PLANNING COMMISSION REPORT
Regular Agenda -Public Hearing Item

**ITEM NO. 3B: PRELIMINARY DEVELOPMENT PLAN FOR BECKHAUS TOWNHOMES;
5275 W. 6th STREET (KEW)**

PDP-17-00695: Consider a Preliminary Development Plan for a multi-family residential development located at 5275 W 6th St. Submitted by Grob Engineering Services LLC on behalf of Beckmeisters LLC, property owner of record.

Figure 1: Proposed Utility Easements

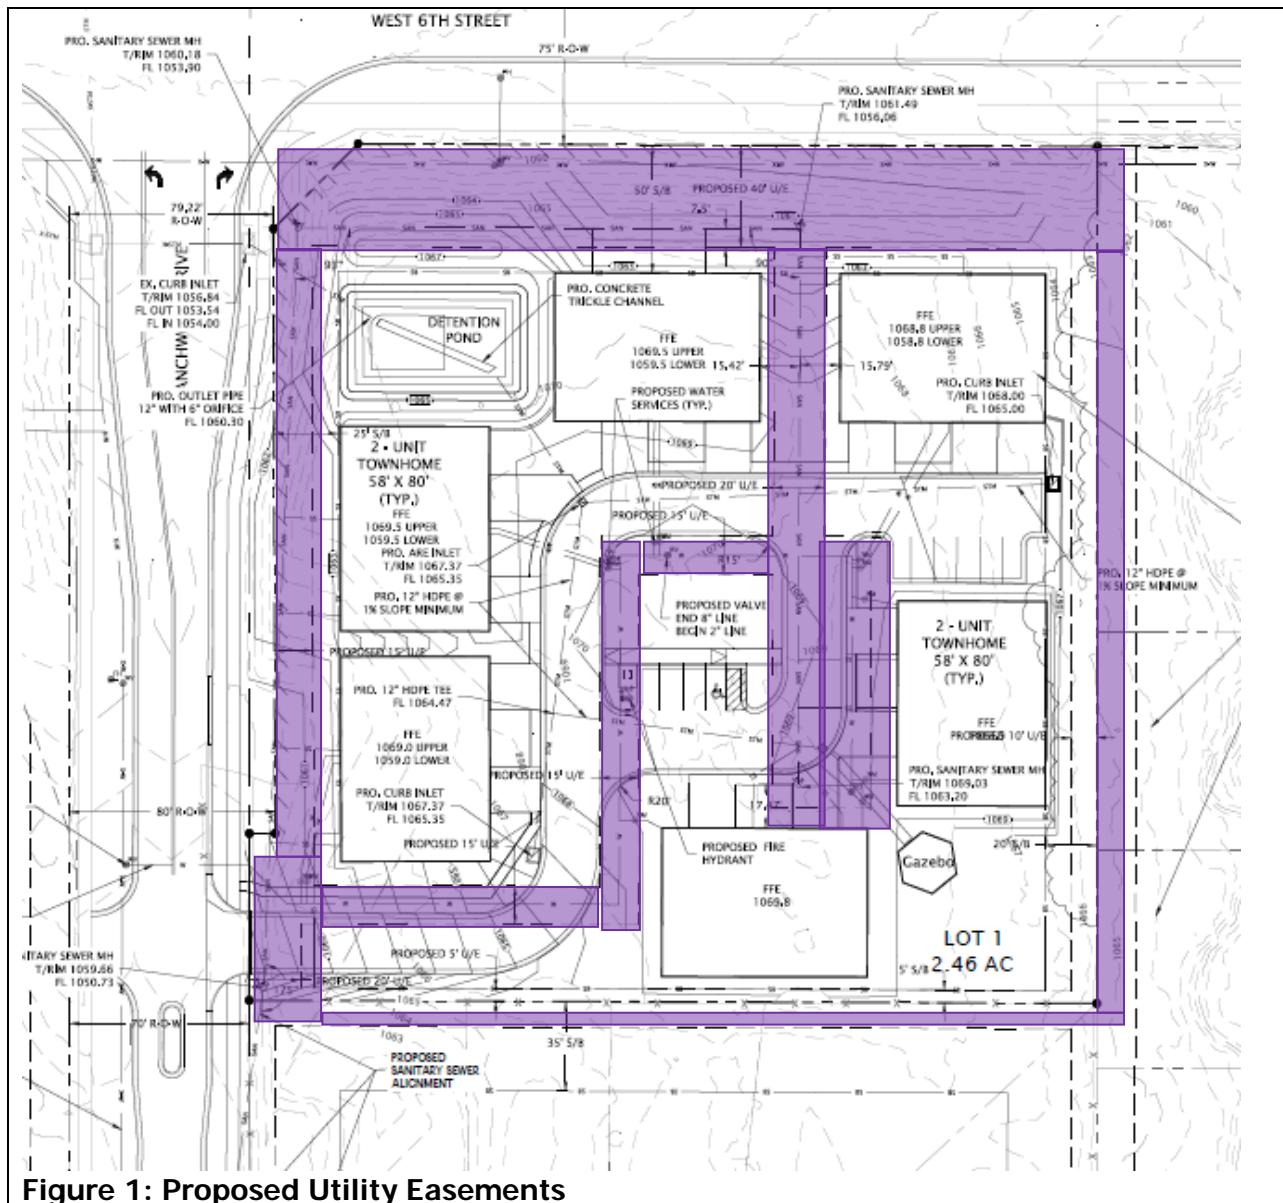
Currently there is a permanent easement located on the property that was acquired as part of the KDOT W. 6th Street improvement and widening project in mid-2005. This permanent easement is proposed to be vacated. There will be a reimbursement due to the City upon vacation of this easement. New easements are proposed for existing and new utility infrastructure. (See Figure 3) A 45 ft. wide easement for an existing 16" dia. Water line will be dedicated along the north property line. A 15 ft. wide utility easement is also located along Branchwood Drive on the west side of the property. The easement accommodates the extension of the sanitary sewer line from the south and provides access to the development. A 5 ft. Utility easement is also proposed along the south property line. This brings an existing 10 ft. Utility easement to the south to a full 15 ft. width as required by current standards. A 10 ft. Utility easement to the east will abut another 10 ft. existing Utility easement.

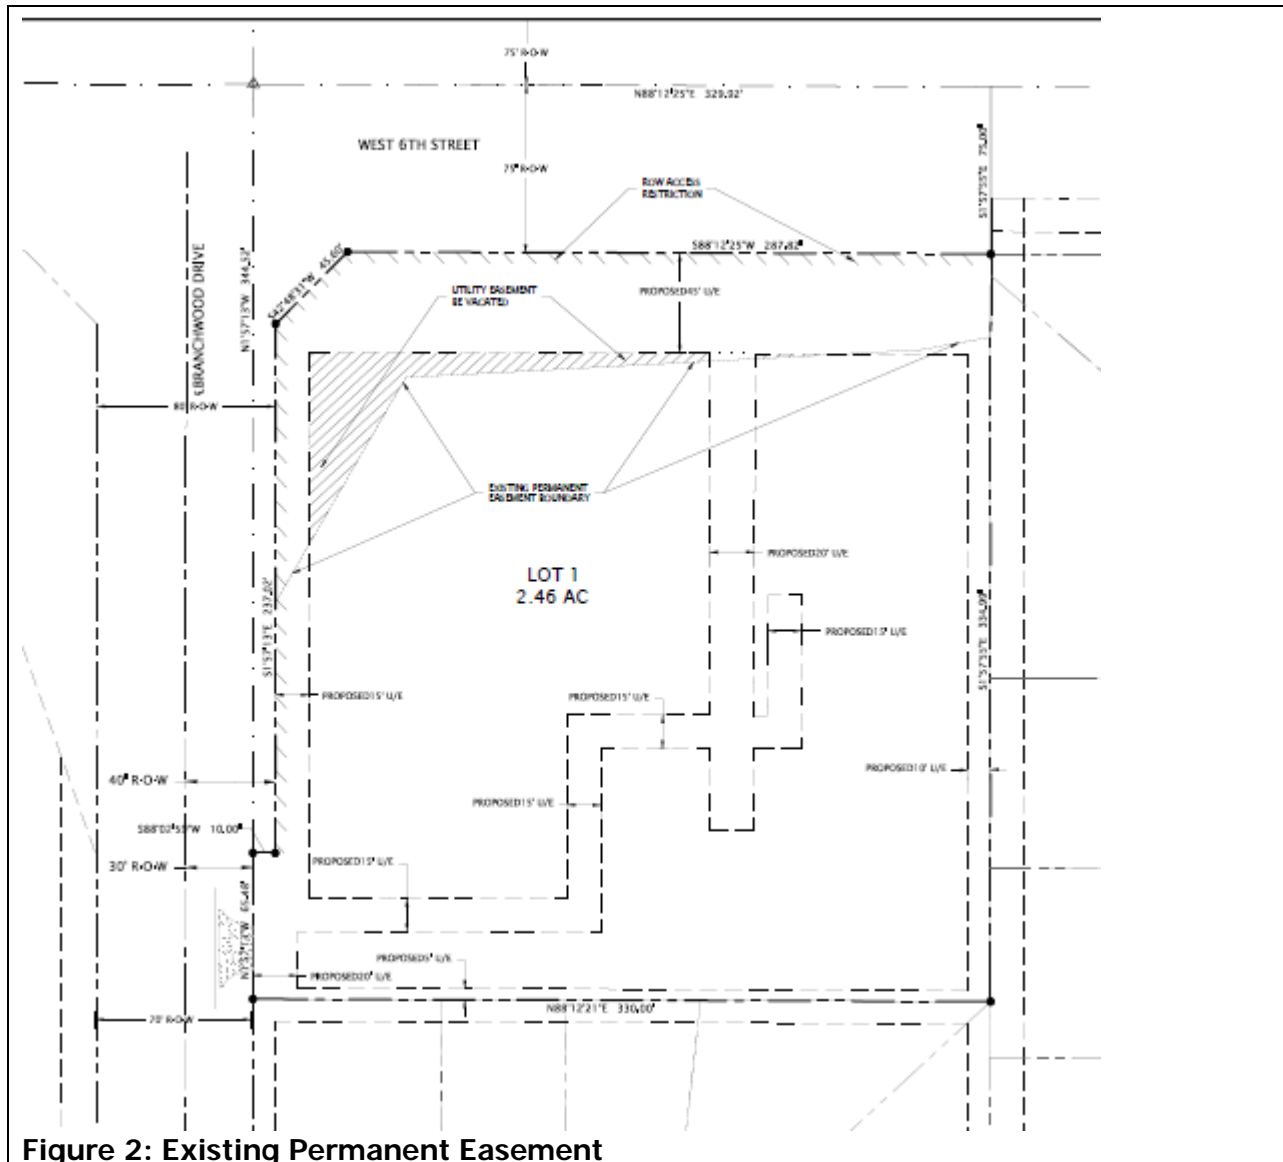
There are existing sidewalks along W. 6th Street. Sidewalks are being extended along Branchwood Drive as part of the current street construction project. The plan proposes an internal walkway to provide pedestrian access throughout the site; however, a connection from the south units to the sidewalk that connects to Branchwood Drive is lacking. The plan should be revised to provide this connection.

1. Provision of a revised Preliminary Development Plan to include the following changes:
 - A sidewalk connection from the south units across to the sidewalk that leads to Branchwood Drive.
 - Dedication of 10' Right-of-Way along the remainder of Branchwood Drive.
 - Dedication of an access easement for sanitation services.
 - Updated landscape notes and common/recreational open space total locations.
 - Note regarding ownership and maintenance of Common Open Space and Non-encroachable areas.
2. Vacation of permanent easement along 6th Street. Reimbursement for permanent easement is to be remitted to the City.
3. Submittal of Public Improvement Plans for utility/infrastructure extensions prior to Final Development Plan submission.
4. Subject to City Commission Approval of rezoning request from UR to RM12-PD.

Figure 3: Proposed Preliminary Development Plan with proposed landscaping.

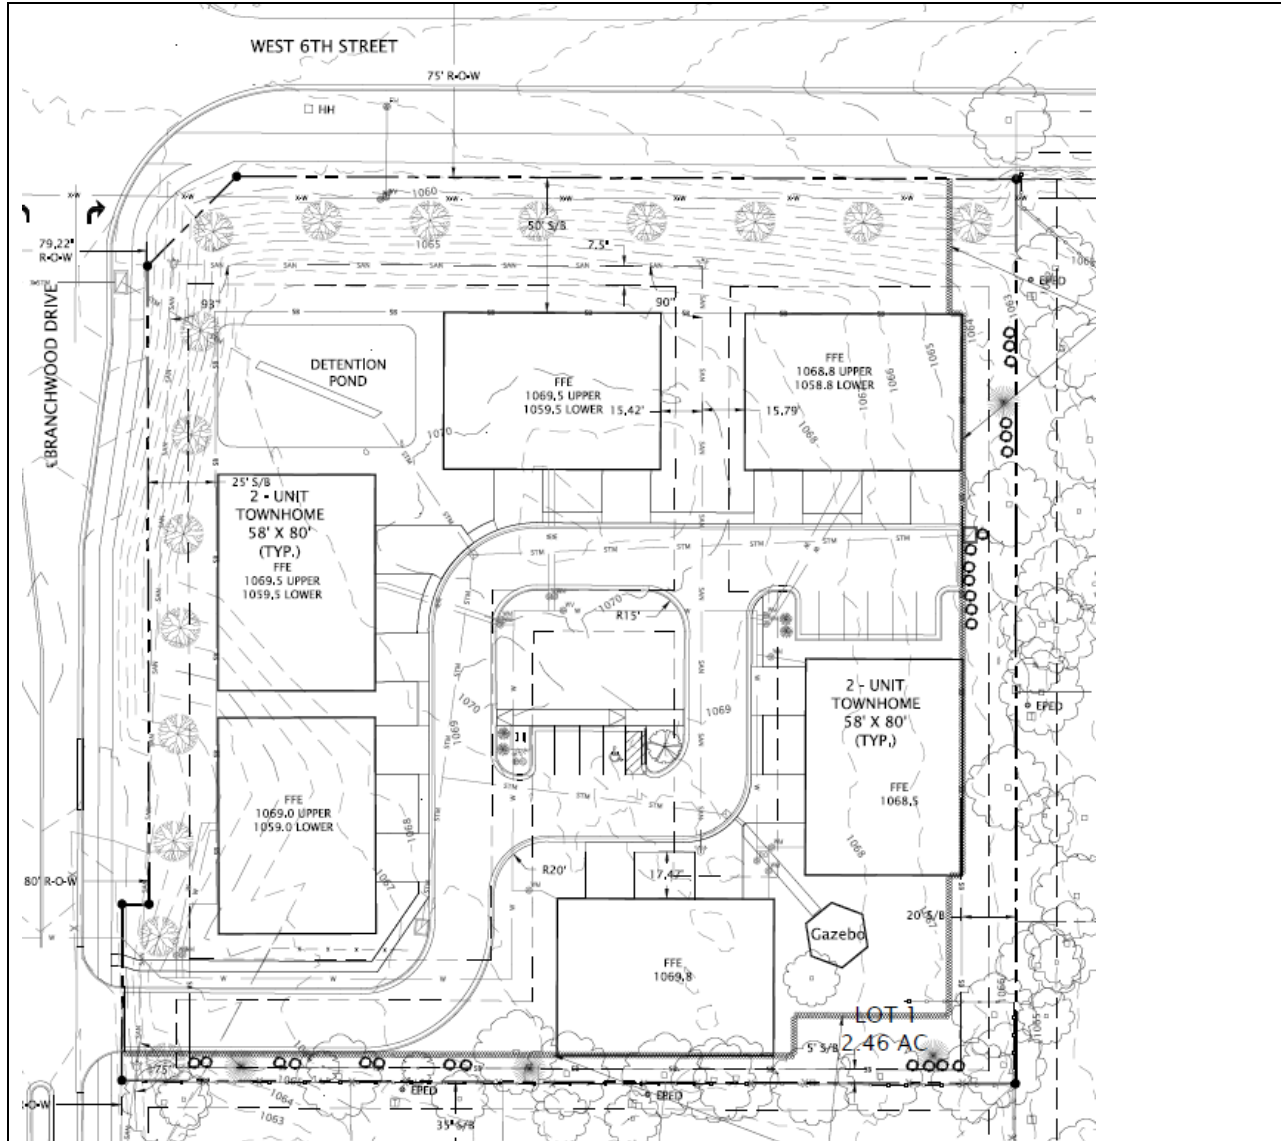
- 3. Sidewalks – *Sidewalks are provided in accordance with City Standards. Internal sidewalks and a sidewalk connecting to Branchwood Drive are provided. The Final Development Plan should also include a sidewalk from the south units across to the sidewalk that connects to Branchwood Drive.*

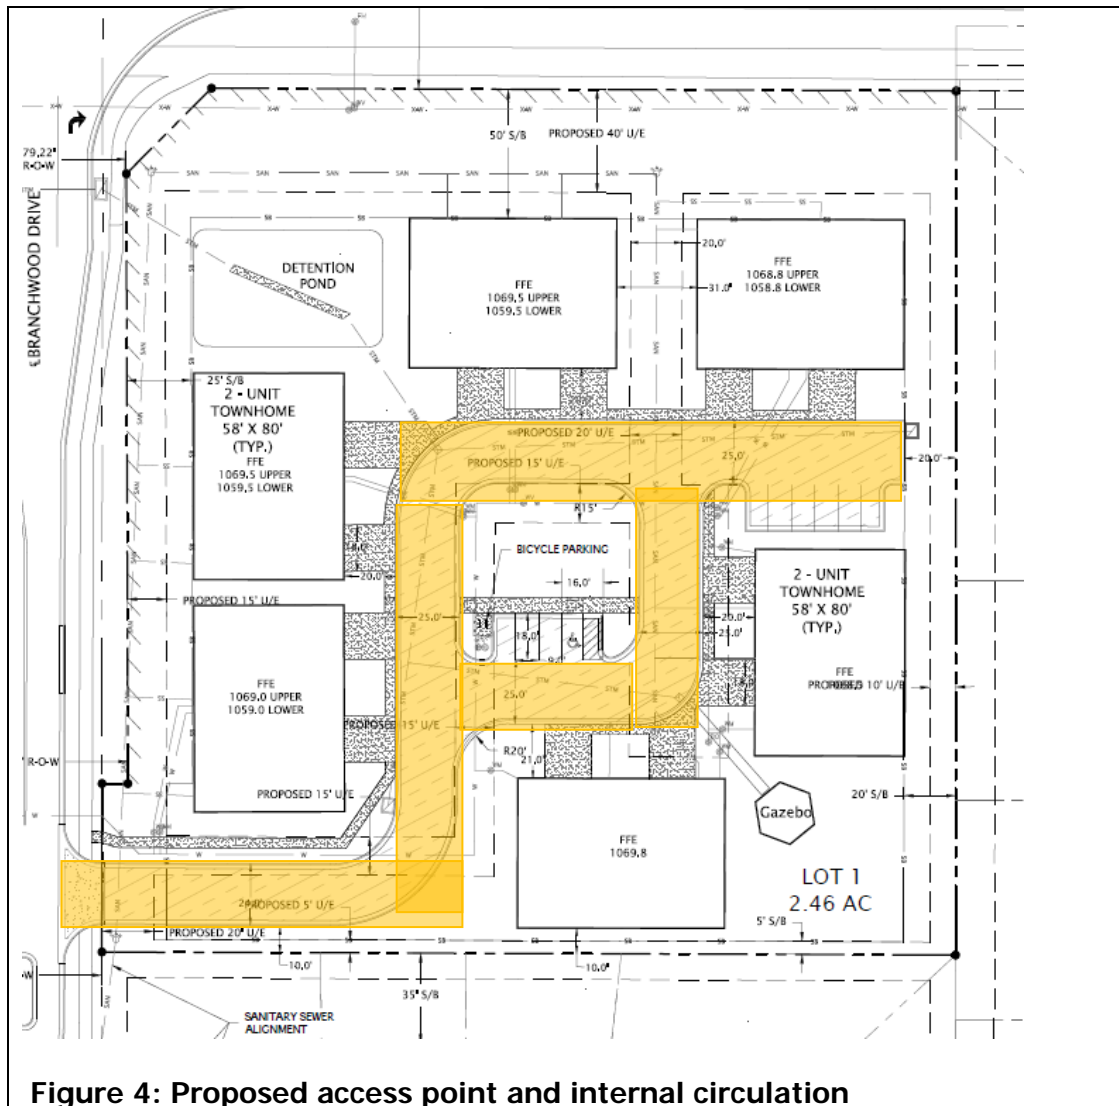
Staff Finding: The plan meets or exceeds the requirement for open space. The Common Open Space required for the Planned Development, 20% of the site (2.46 acre X .20 = .49 acres.) exceeds the outdoor area that is required for a residential development in the Base RM12 District. The amount of Common Open Space that is being proposed for this development is adequate. The Preliminary Plan shall outline the areas of Common Open Space dedicated to recreational uses.
